BID ADDENDUM NO.1

2181539 Bank on Buffalo, Niagara Falls, NY

There was an error during the printing process that caused the structural & HVAC items to not appear in the Architectural drawings. Some of the drawings being replaced are only to show the missing items for clarification. No actual changes are occurring on these sheets. Any changes to the drawings are clouded & tagged.

A101

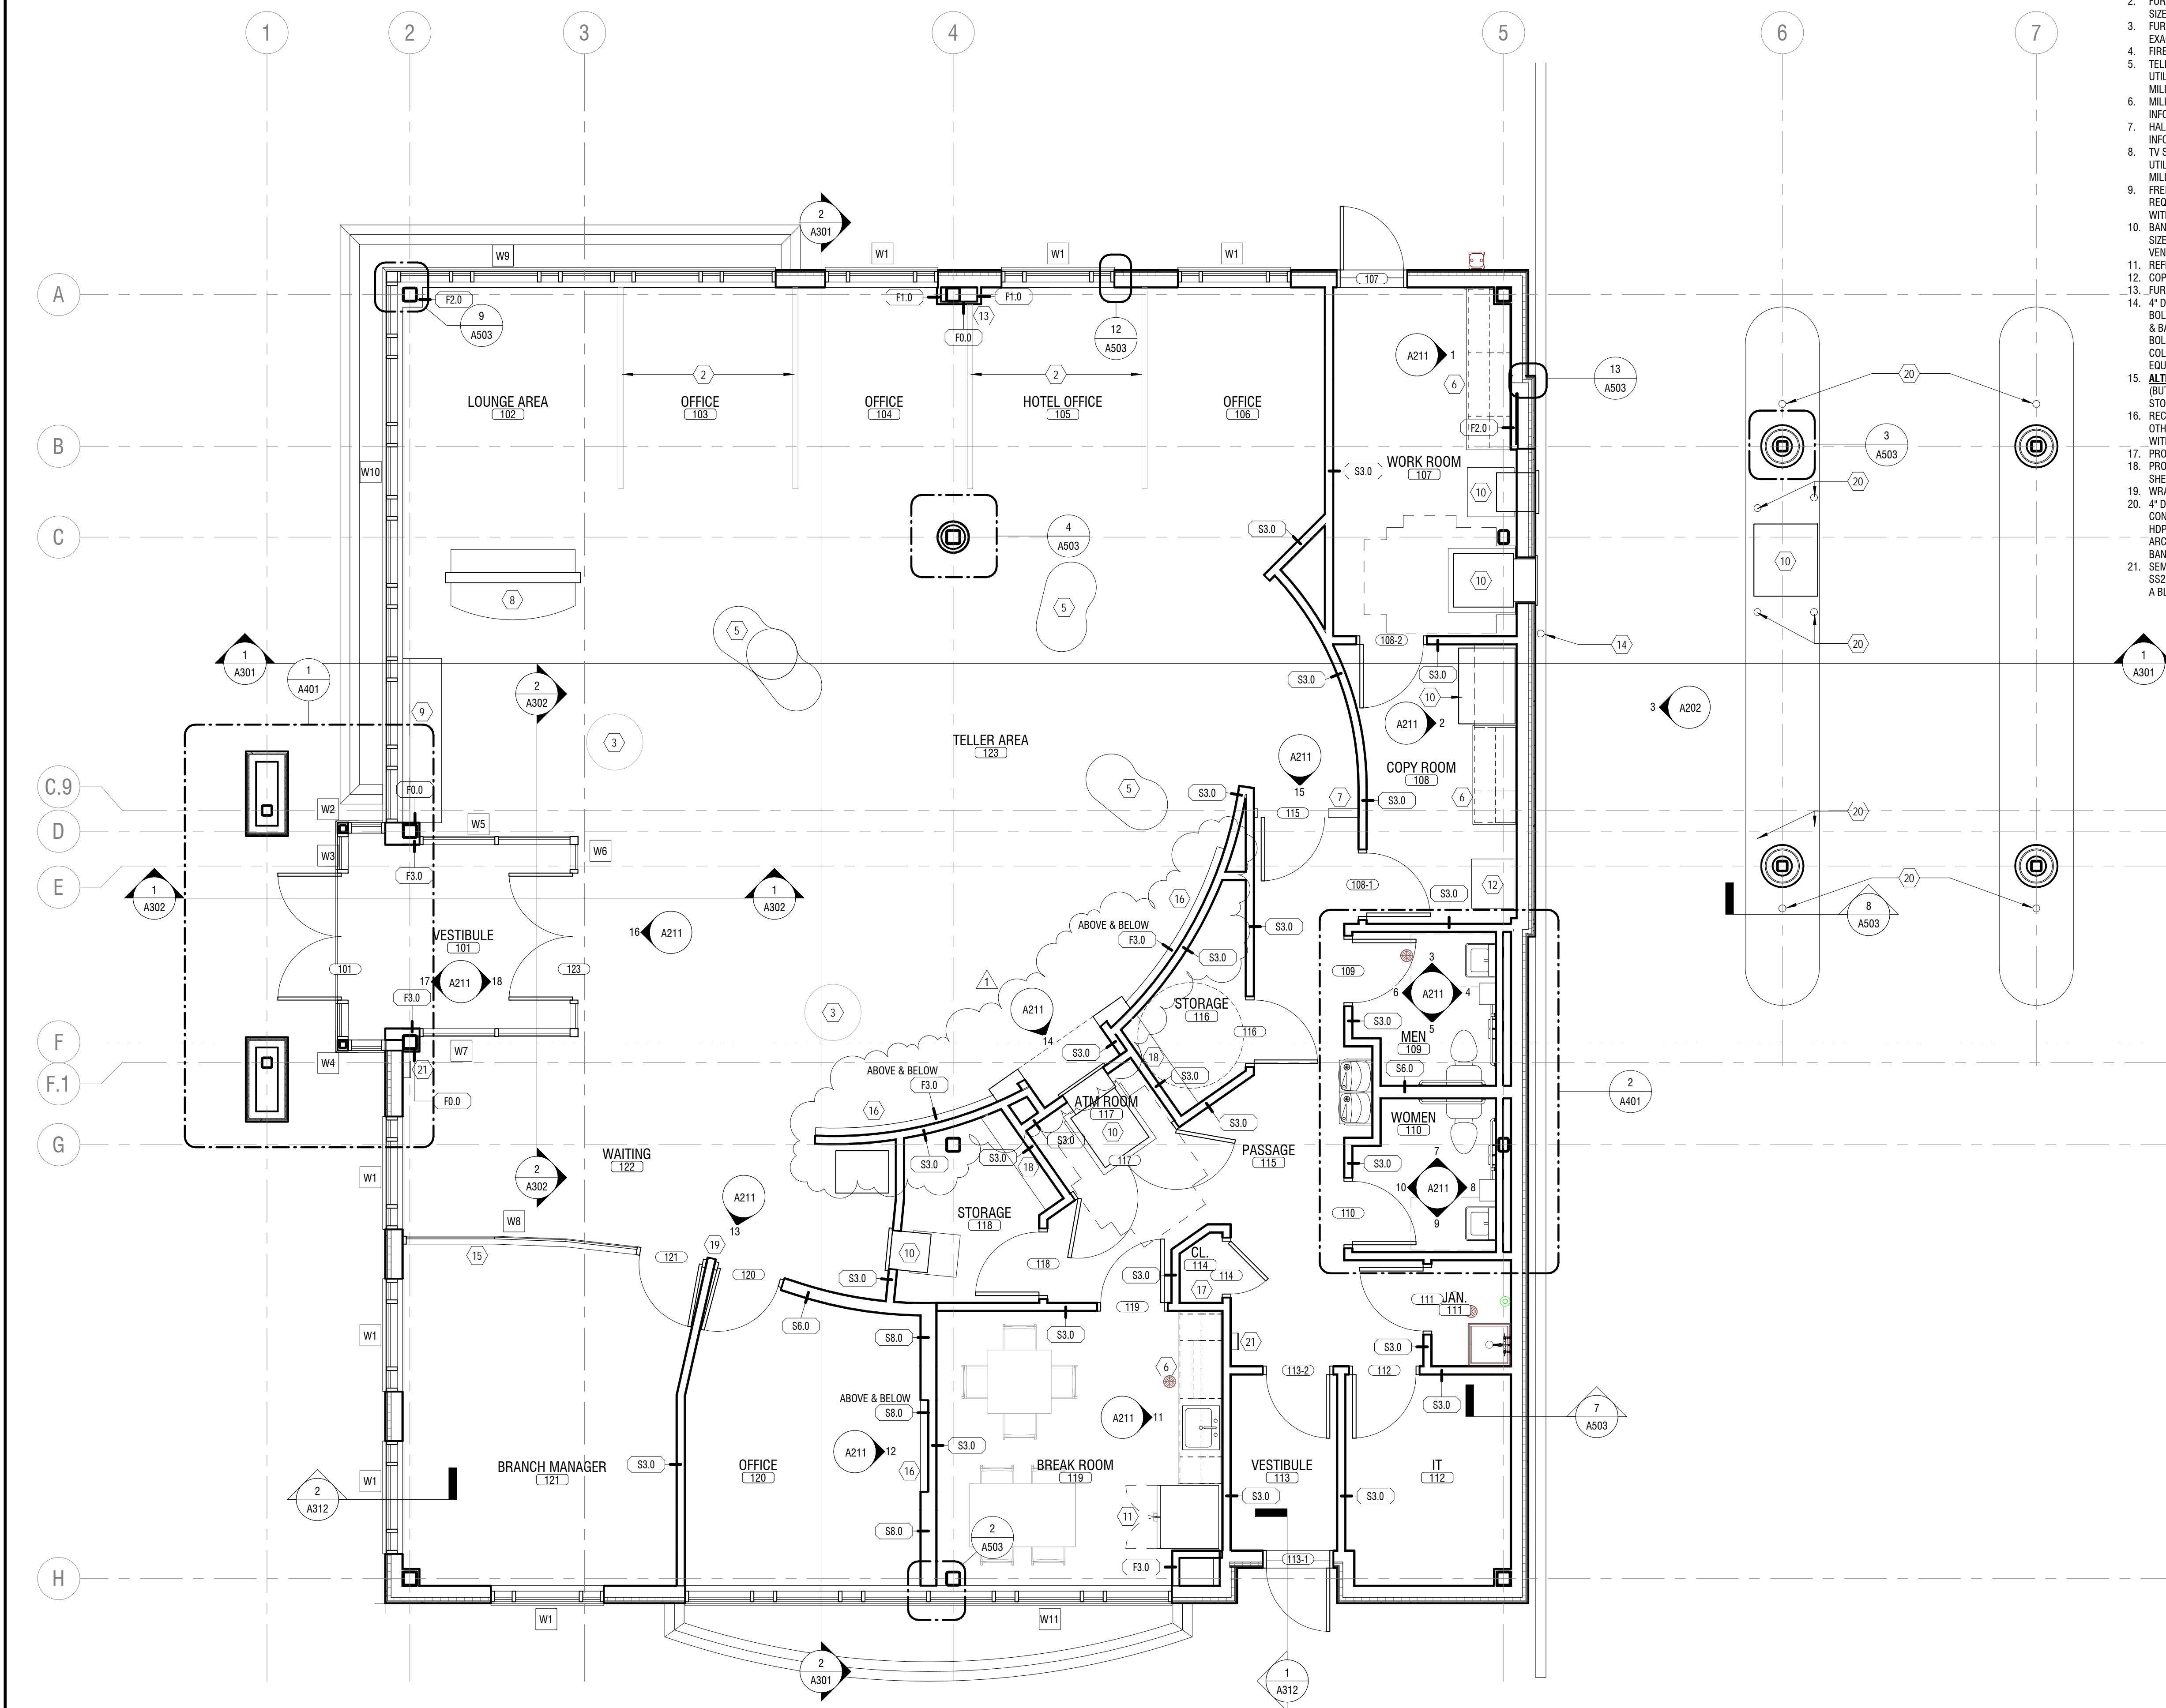
1. DELETE Drawing in its entirety
2. ADD replacement Drawing A101
3. Changes to the curved Customer feature (DIY) wall
4. Structural items are now shown on drawings.

FIRST FLOOR PLAN - DIMENSIONS

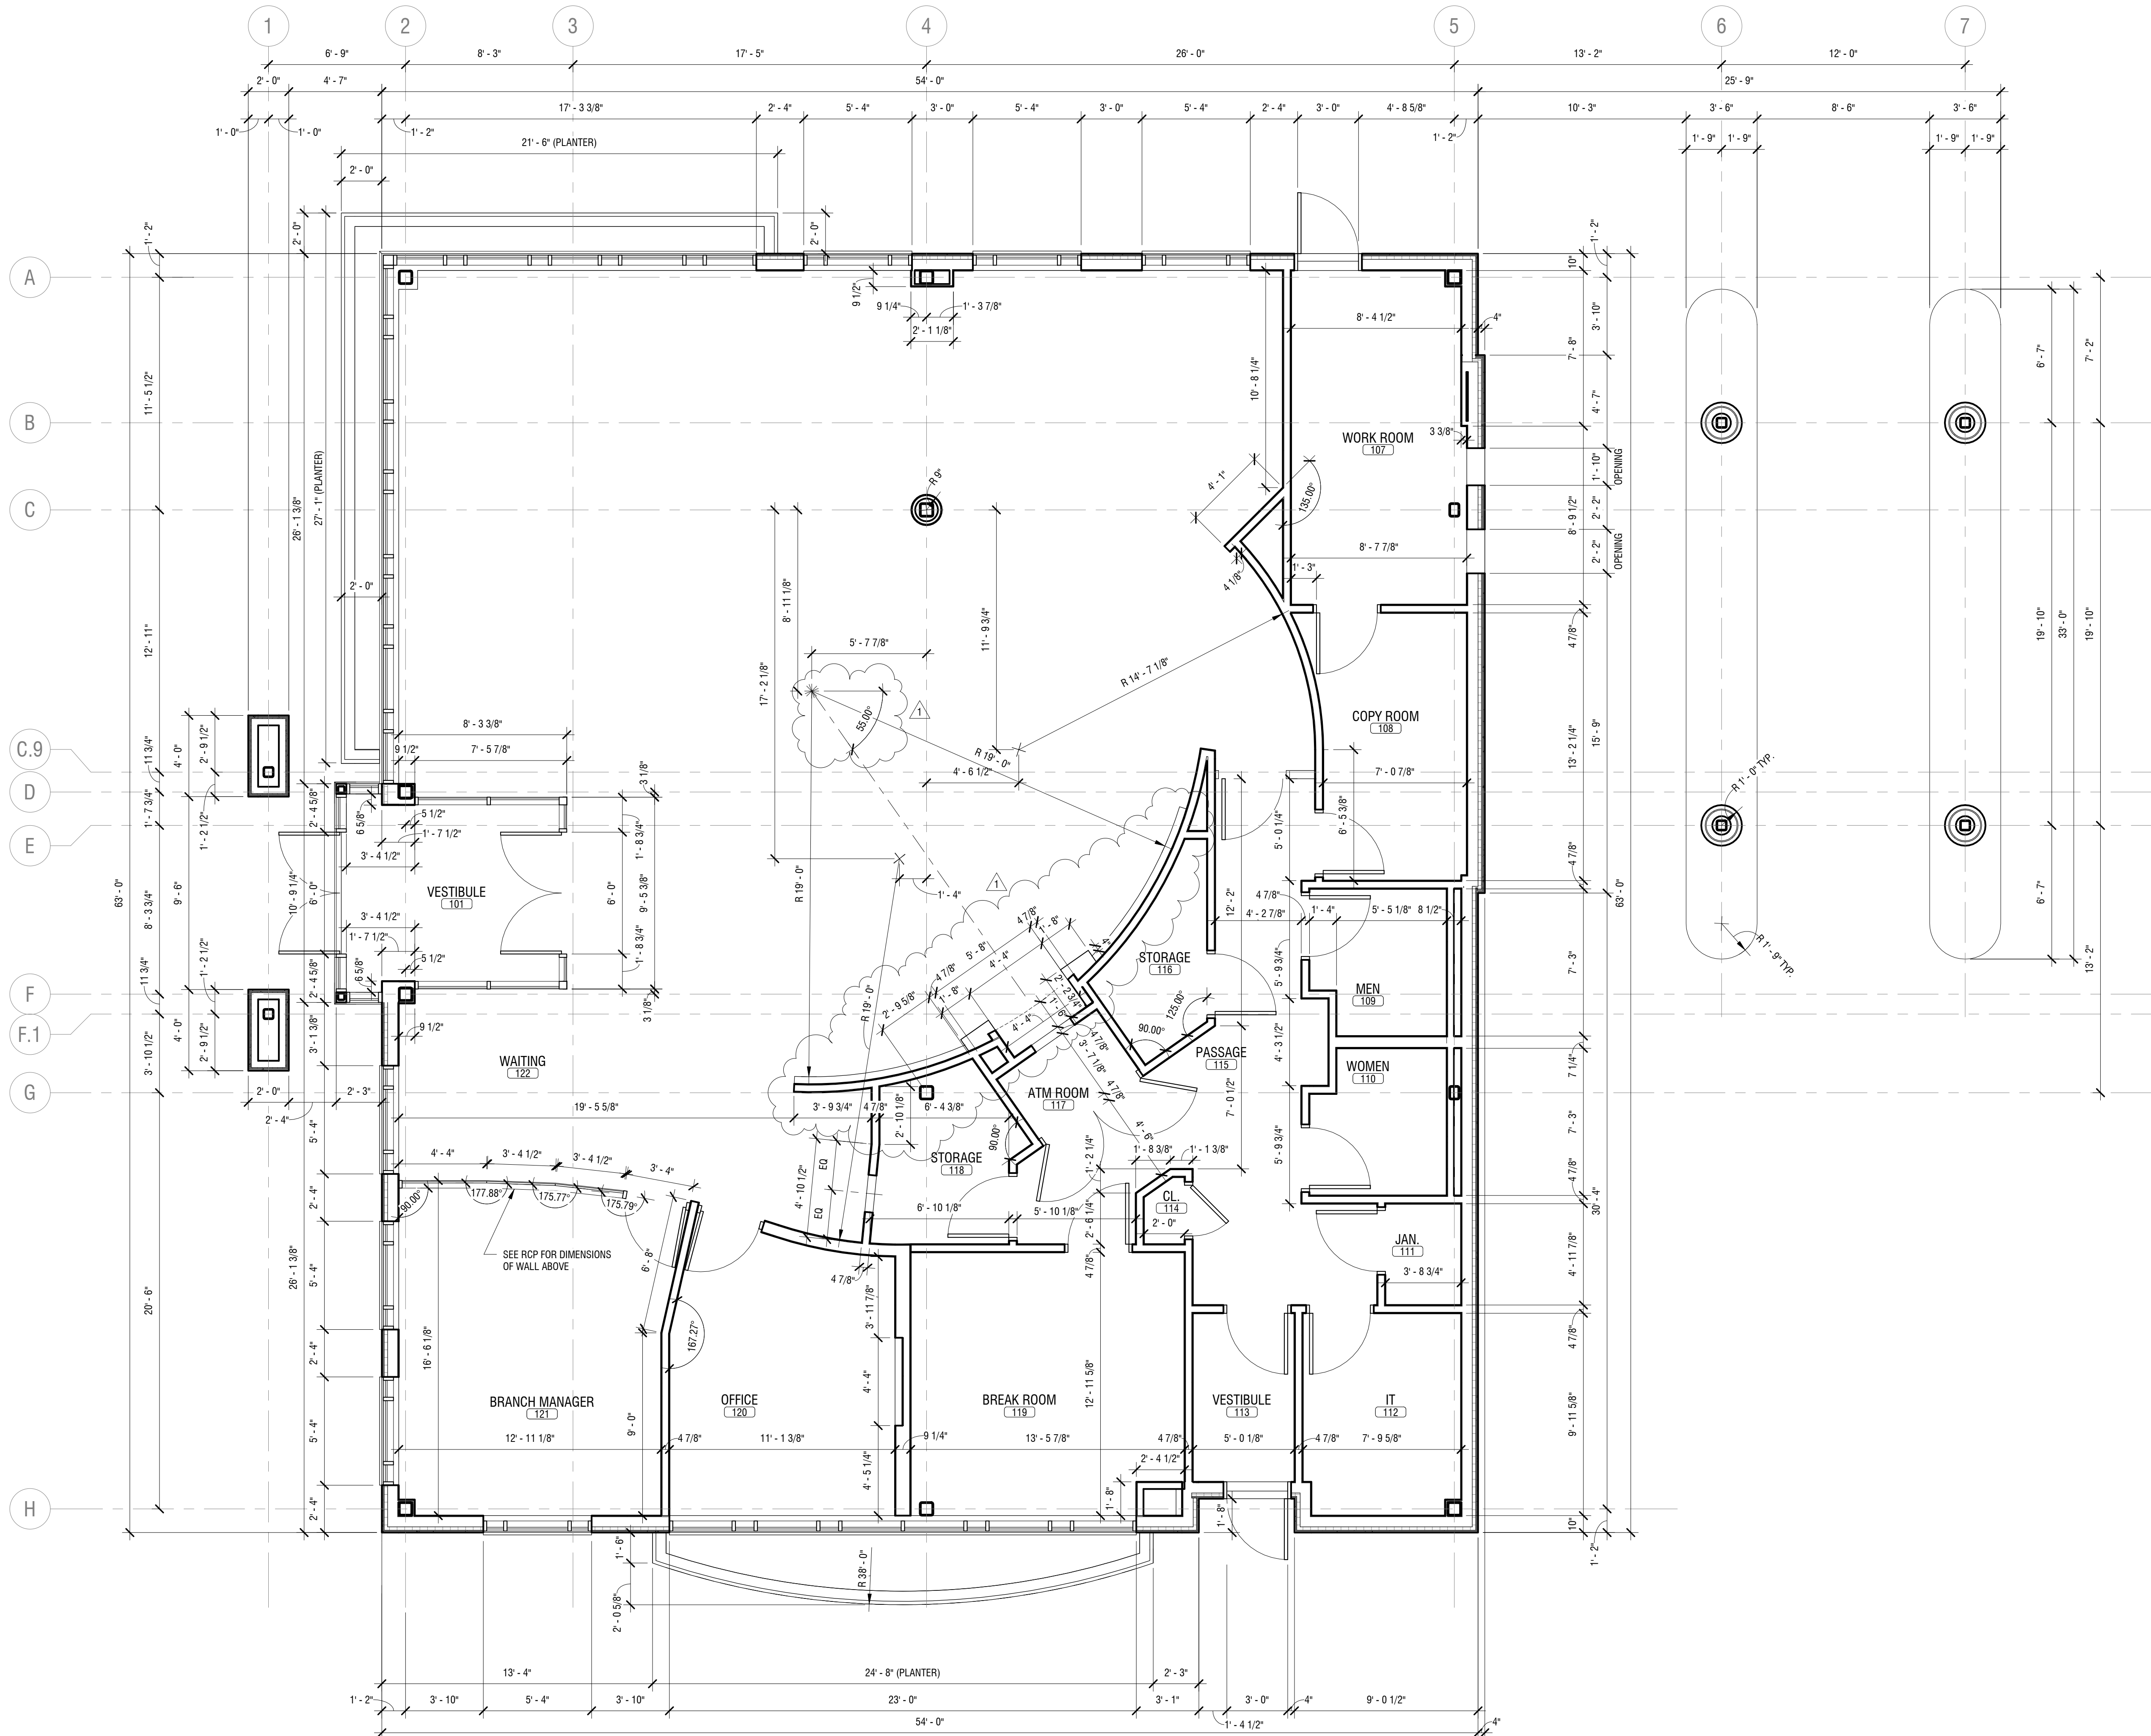
1. DELETE Drawing in its entirety
2. ADD replacement Drawing A102
3. Changes to the curved Customer feature (DIY) wall
4. Structural items are now shown on drawings.

A111

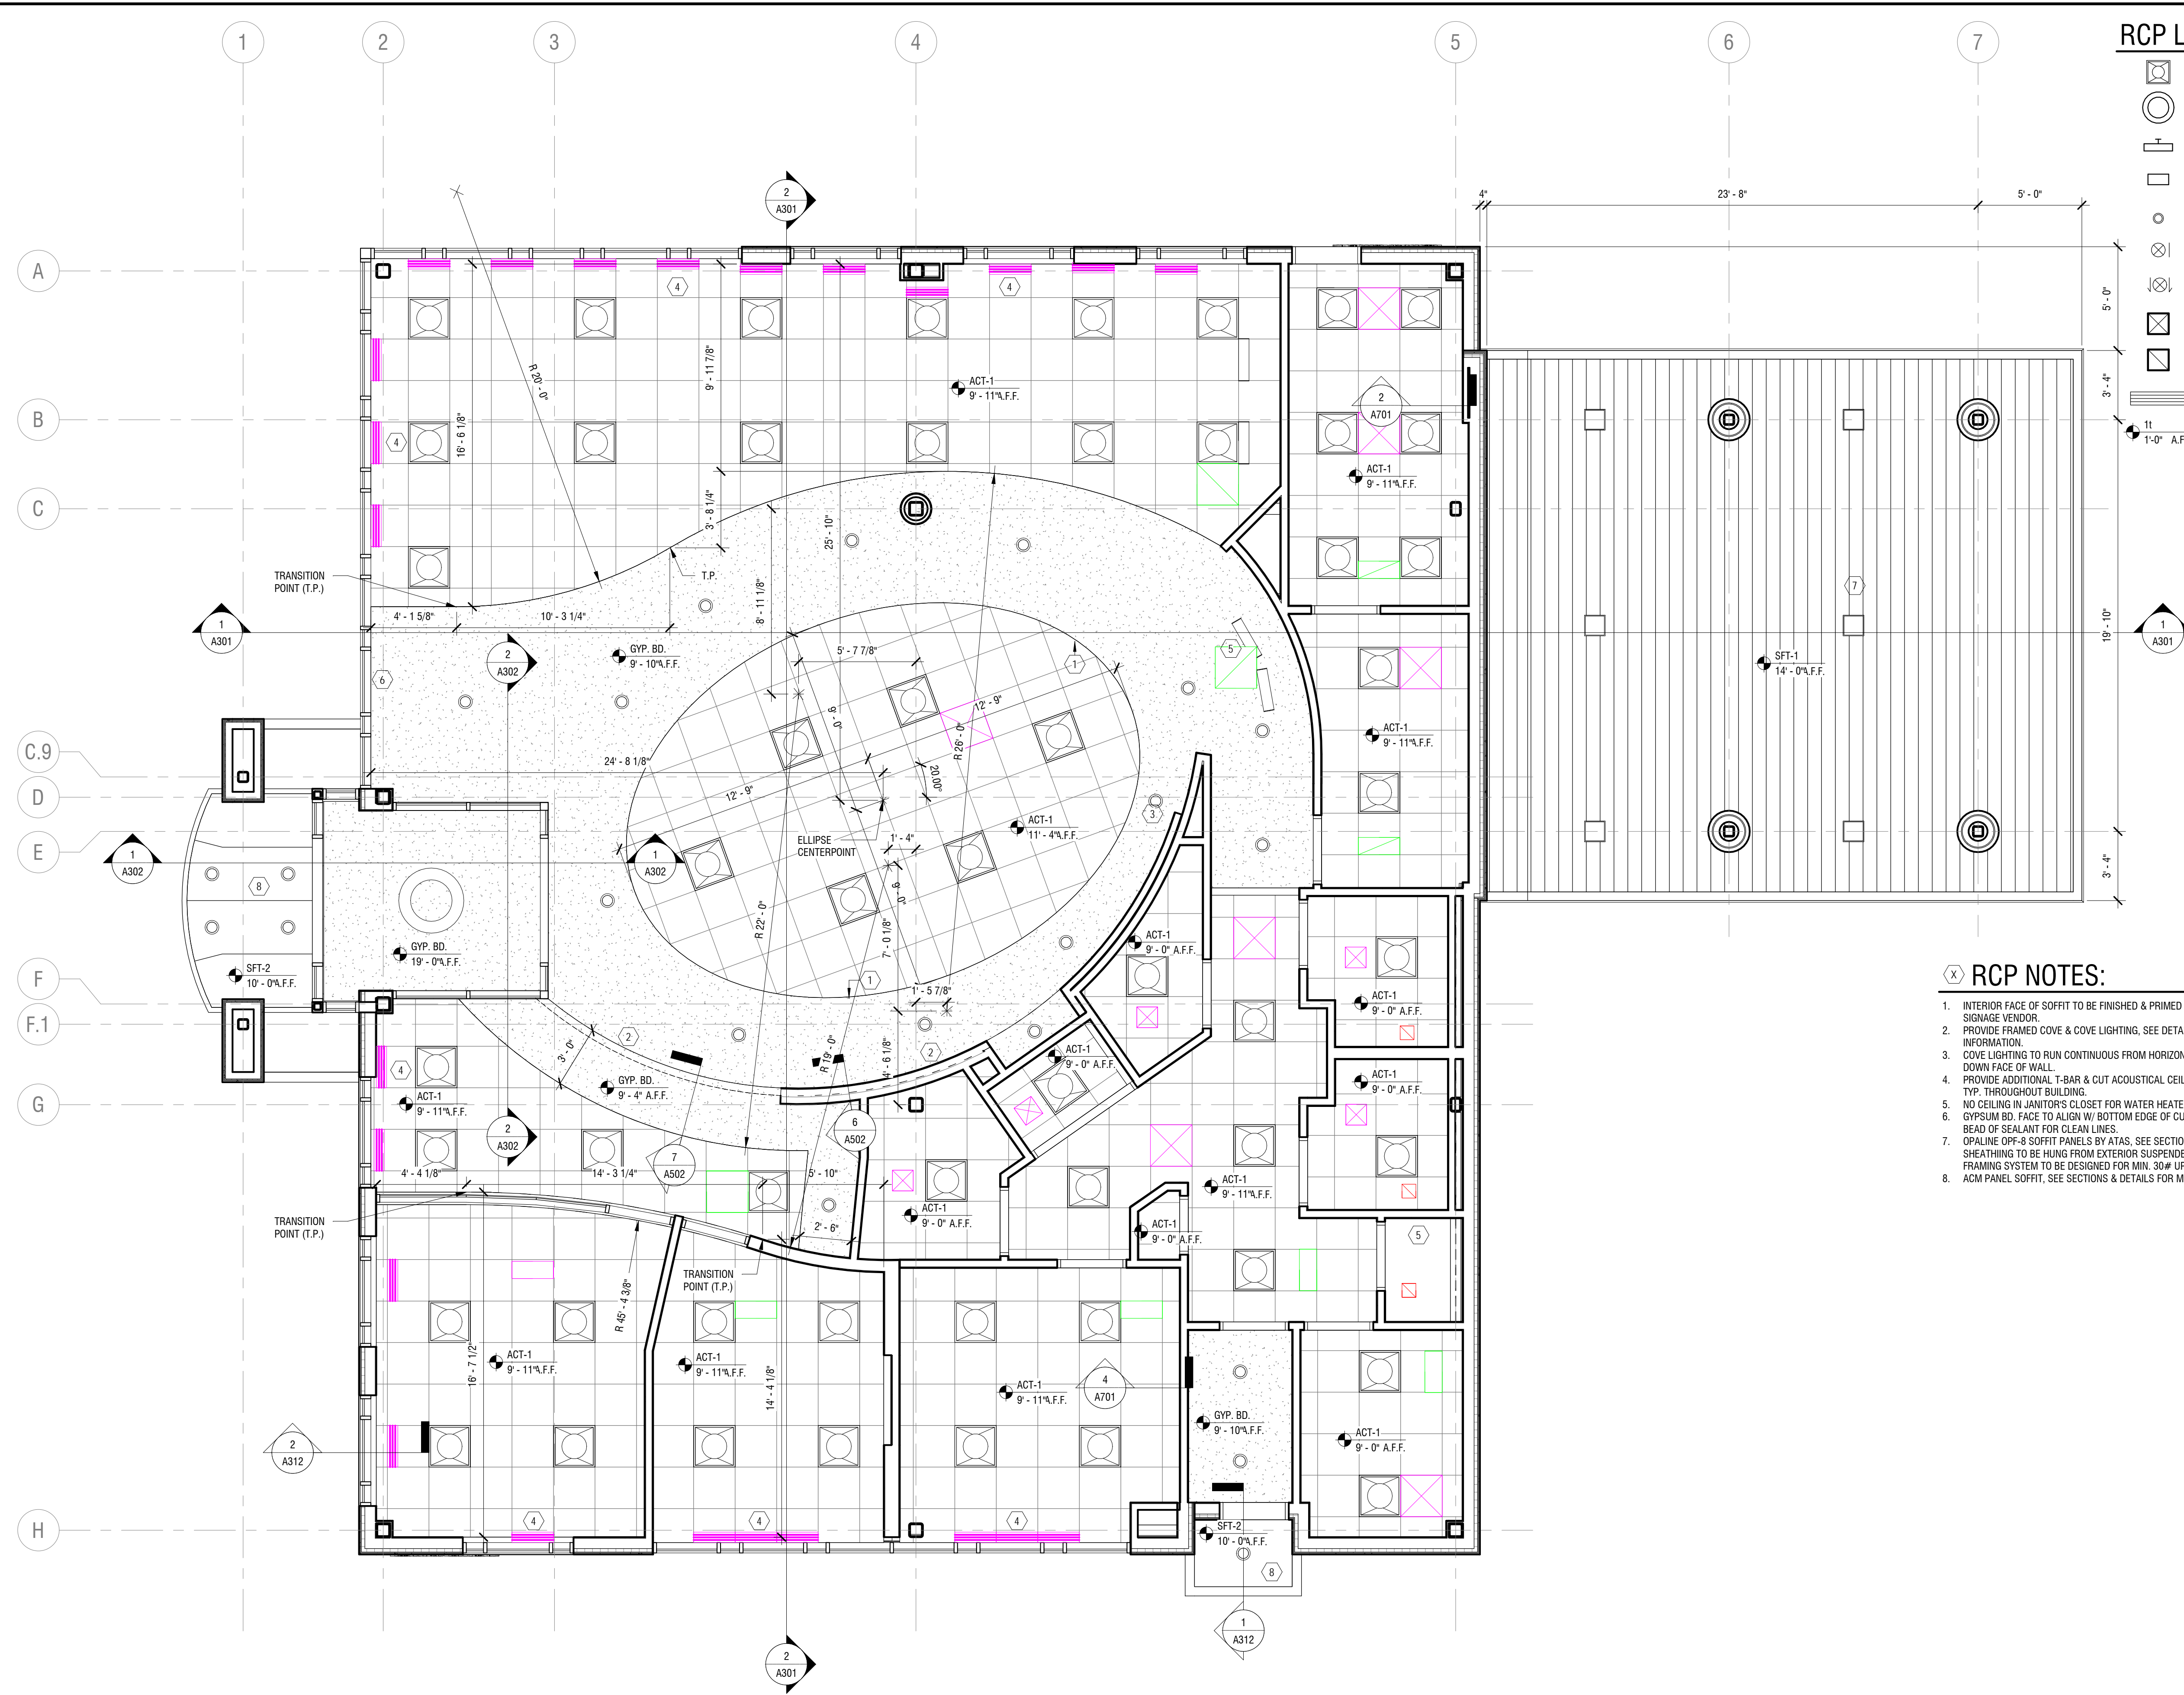
1. DELETE Drawing in its entirety
2. ADD replacement Drawing A111
3. HVAC shown on drawings.
